**CM MUNCASTER MILL, LLC  
CONDITIONAL USE NO. CU202407 AND  
PRELIMINARY FOREST CONSERVATION PLAN NO.  
F20230500**

Request for Conditional Use approval to construct a (Design for Life) Townhouse Living community in the R-200 Zone.

No. CU202407

Completed: 12-22-2023

Figure 5: Southwest Corner of Site

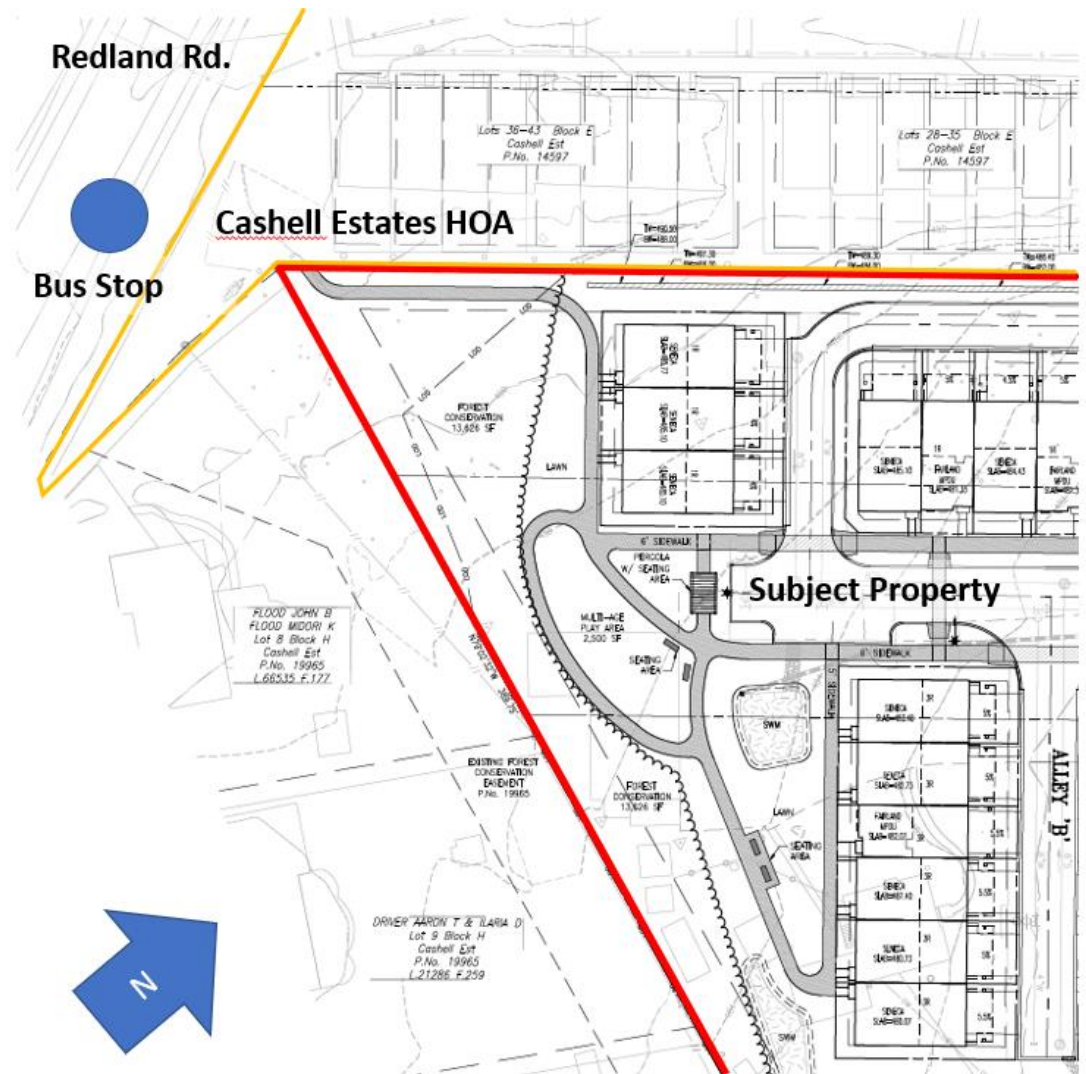
An extension of this trail is proposed into the western corner of the site closest to Redland Road (Figure 5), with details to be determined as part of the Preliminary Plan Process. This is to accommodate potential future connectivity to Redland Road, with a public access easement to be provided as part of the Preliminary Plan. A small corner of communally owned property by the neighboring Cashell Estates HOA (outlined in lighter shaded line) separates the Subject Property (outlined in darker shaded line) from Redland Road. Conversations are ongoing with the HOA to explore options for connectivity across this portion of property, to be determined as part of the Preliminary Plan process. If found to be agreeable by the HOA, the Applicant will provide the paved connection. This connection is important to pursue for the community to

access Redland Road, in particular the nearby bus stop which serves the Ride On 53 and 57 bus lines, both providing access to Shady Grove Metro and points beyond. Without this link, riders from the Application must walk an additional 1/3 mile, or 6 minutes, to access the stop, a significant hurdle for all users, particularly those with mobility impairments. Bus riders from the community may instead be forced to rely on the 53 line only, which provides a stop along Muncaster Mill Road fronting the Subject Property, which only operates peak weekday hours, with a limited frequency of every 50 minutes, or for individuals with mobility challenges, rely on more expensive and inconvenient dial-a-ride services. Staff will continue to work with the Applicant and Cashell Estates HOA to explore options to provide this connection.

- d. As part of the Preliminary Plan, all proposed intersections must provide crosswalks and ramps across all four legs of the intersection.
  - e. As part of the Preliminary Plan process, the Applicant will continue to explore options with Planning Staff to extend a paved trail connection to Redland Road

Figure 8: Proposed Variance Tree Impacts

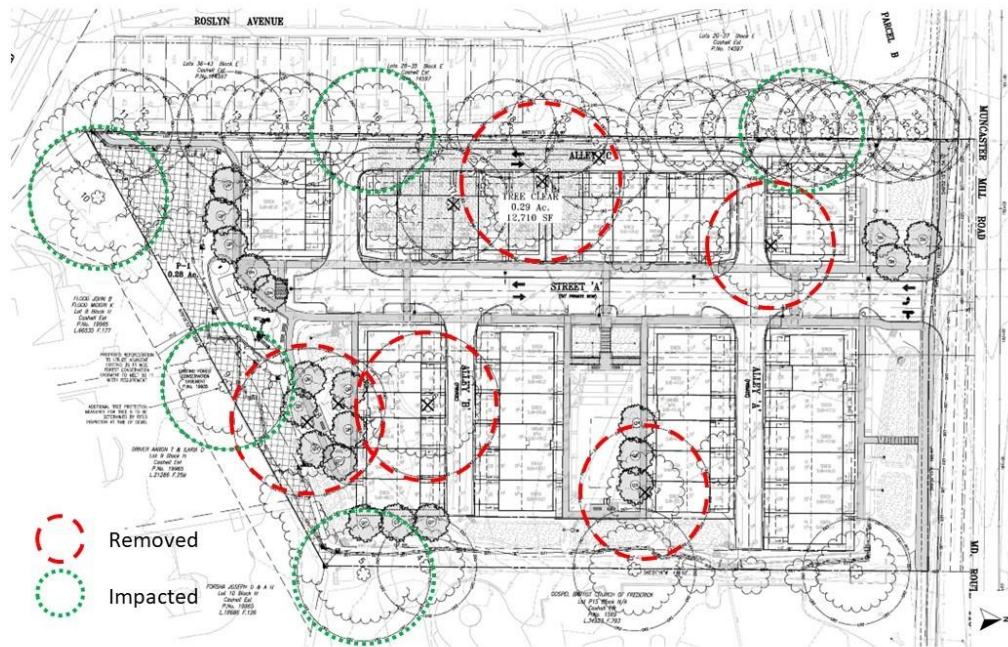
Along the western edge of the site, a number a of trees are impacted by Alley 'C'. This alley is needed to facilitate rear loading units and to allow the proposed townhomes to front on Street 'A'. These streets and alleys must be at least 20 feet wide to avoid fire access related height restriction for the proposed townhouses and to allow fire truck access to all portions of the site. This requirement further limits flexibility for the design. Along with the alley and road restrictions, each dwelling unit must have two parking spaces for residents. This requirement means the driveways must be at least 20 feet long to accommodate a parked vehicle in addition to the garage space.

Staff has reviewed this Application and based on the existing conditions on the Subject Property and has determined that there is an unwarranted hardship.

Staff recommends that mitigation for the loss of the specimen trees be provided onsite. Mitigation should be at a rate that approximates the form and function of the tree removed. Staff recommends that replacement occur at a ratio of approximately 1-inch caliper for every 4-inch DBH removed ( $268 \times .25 = 67$ ). Mitigation for the removal of the five (5) trees must be provided in the form of native canopy trees with a minimum size of three (3) inches in diameter at breast height. While these trees will not be as large as the tree lost, they will provide some immediate canopy and will help augment the functions lost.
